Published: 11/19/68

Appendix to check\_configuration, BL.3.05  
A. Sasaki

Figure 1. <fault\_vector> for tests on Memory Controllers, wirings, and Control Assignment.

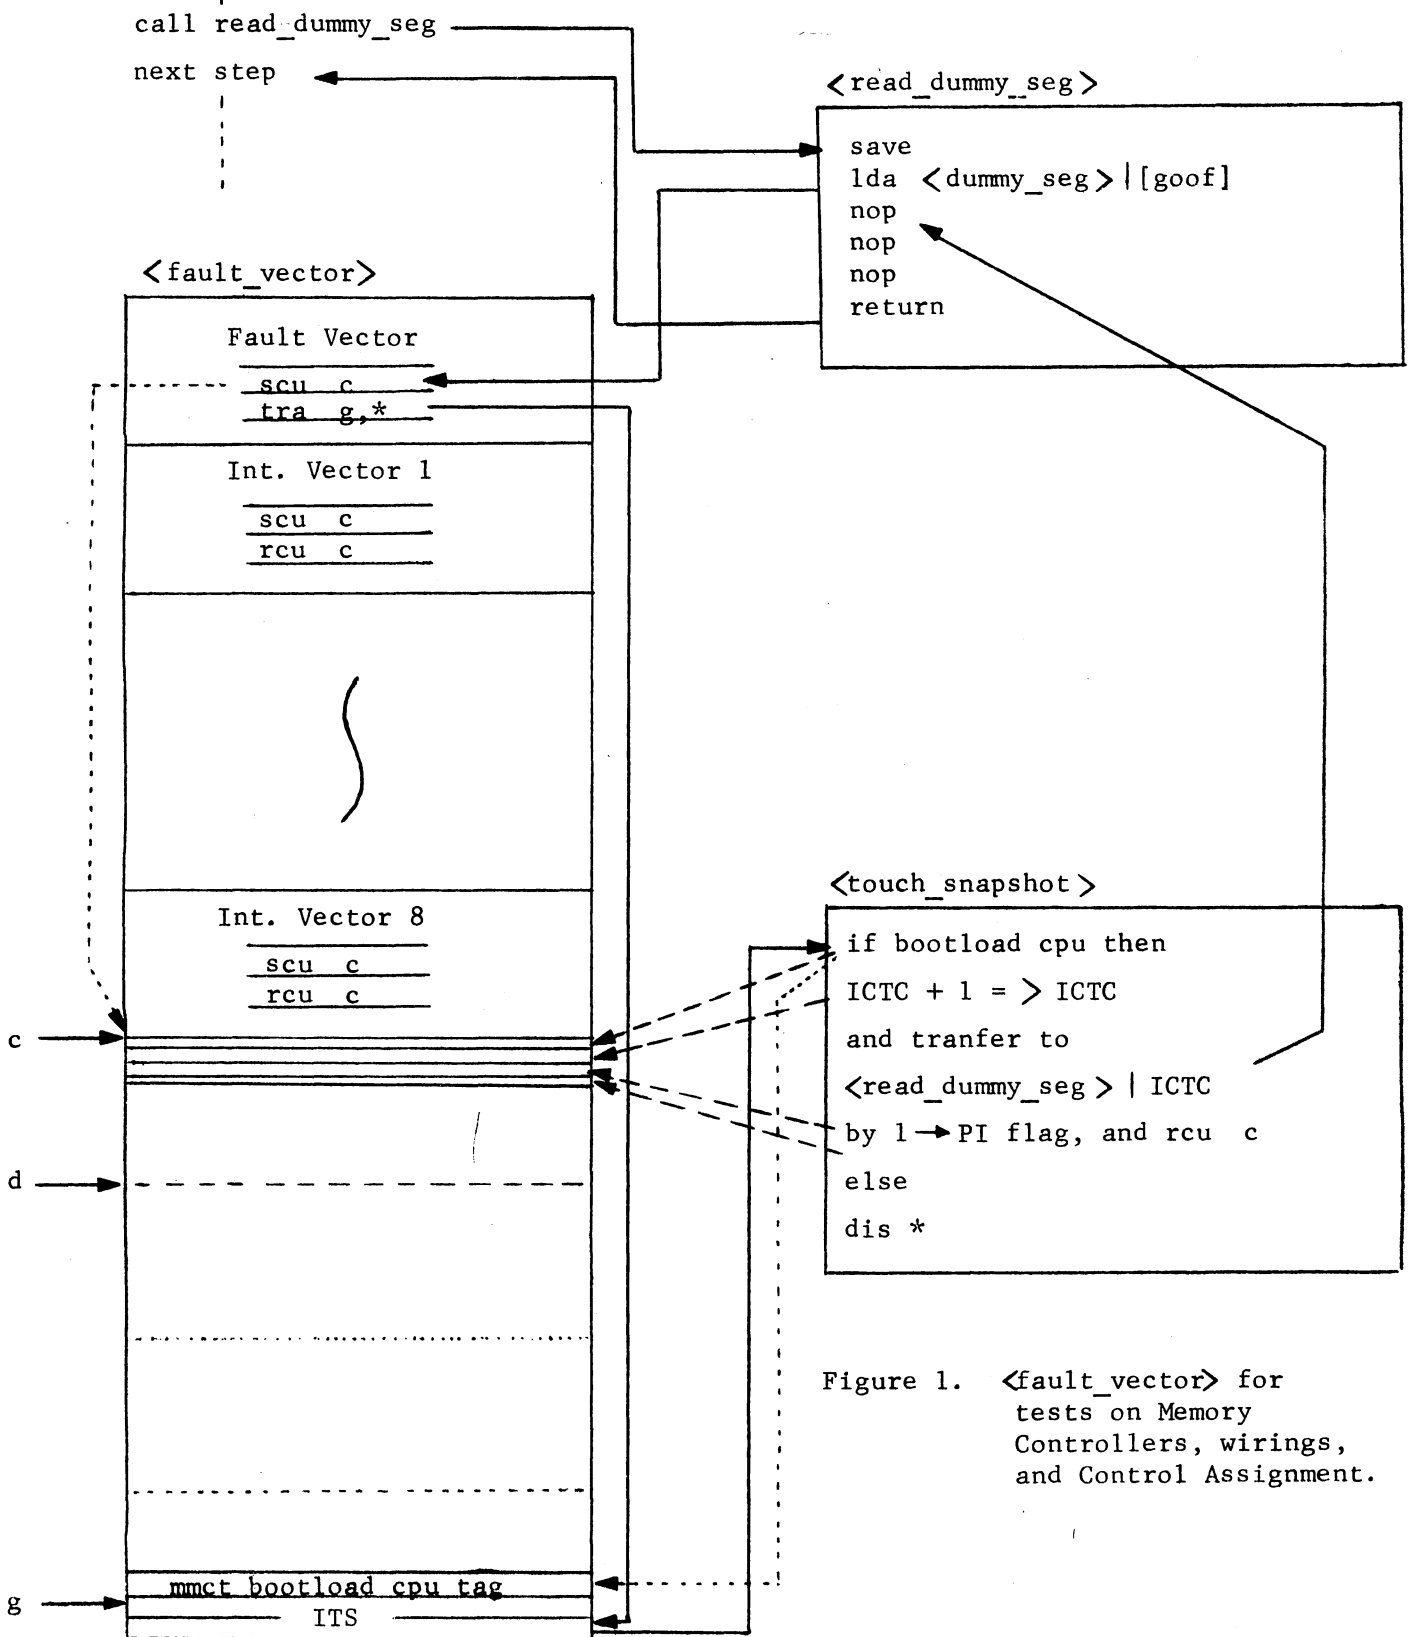
Figure 1 in BL.3.05 was a wrong copy.

Figure 1 in this section is the correct copy.
